TITLE: Sheet_2		REV: 1.0
嘉立创EDA	Company: Your Company	Sheet: 1/1
	Date: 2023-12-10 Drawn By: Denjhang

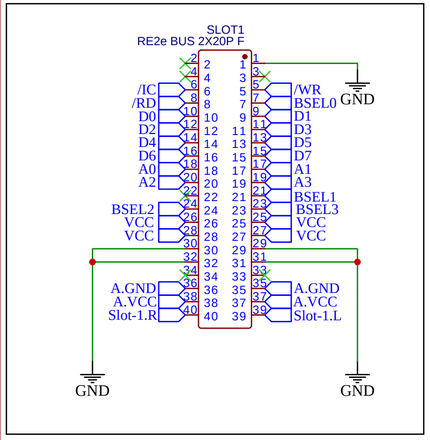
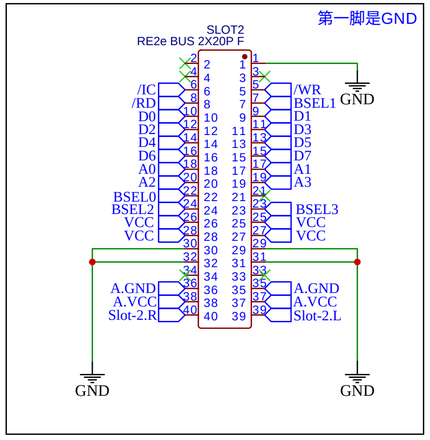
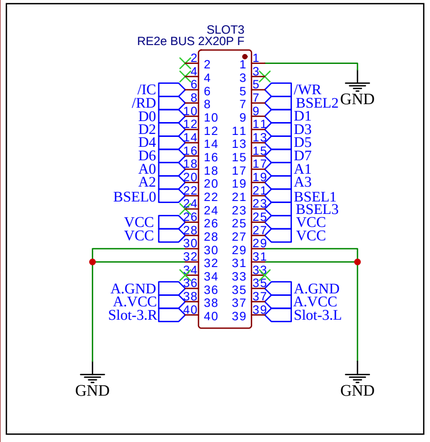
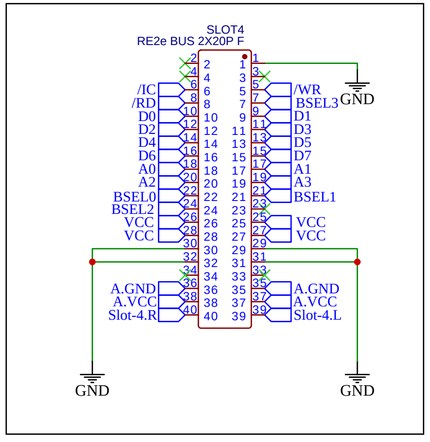
此处电阻需要调整

1.每个卡板加B0-3
2.精简滤波电容
3.加饻12V
4.轨对轨贴片运放
5.删除SCK
6.电阻电容远离隔离柱
7.加9V输入

1.添加TPA6111
2.添加输入电压标识

1.删除饻12V
2.删除电源输入

1.删除耳机放大器。

1.纠正bus线序错误

1.删除整流桥，BNX，
2.精简滤波电容
3.删除Work-LED
4.删除SCK
5.耳机孔放在电位器左侧以避免干涉
6.添加IB0505S
7.添加自动切换主副电源的电路

1.测试发现电源切换电路没屌用，删了
2.单USB供电一切正常，插DC发出高频噪音，考虑共地噪音
3.结合旧版本发现必须彻底隔离DC-GND和USB-GND
4.必须添加MCU开关，PIC没必要，仅IAP
5.必须添加电源切换开关二选一。
6.必须拆除所有IAP晶振，那会影响主时钟，否则请用24M
6.PIC考虑使用无源晶振
7.必须下对齐电位器
8.MCU换成LQFP48封装更便宜

1.测试发现经常性无法启动，发现IAP必须在所有地联通的情况才能启动，短接IB0505S原边和副边的地
2.考虑改USB-CH340模块，让DC供电时整板使用DC电源
3.现阶段只能完美USB供电使用CMOS音源，必须短接IB0505S两个地。
4.或者两个地都不短接，则有概率无法启动
5.两种方案：一是让USB-CH340隔离地，下面不隔离
二是USB和MCU永远公用VCC和GND并且不用稳压，DC供电仅给卡槽使用
6.不隔离，IB0505S严重发烫

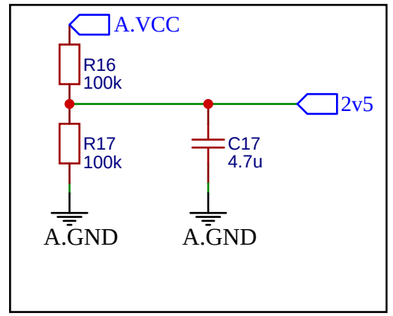
多余
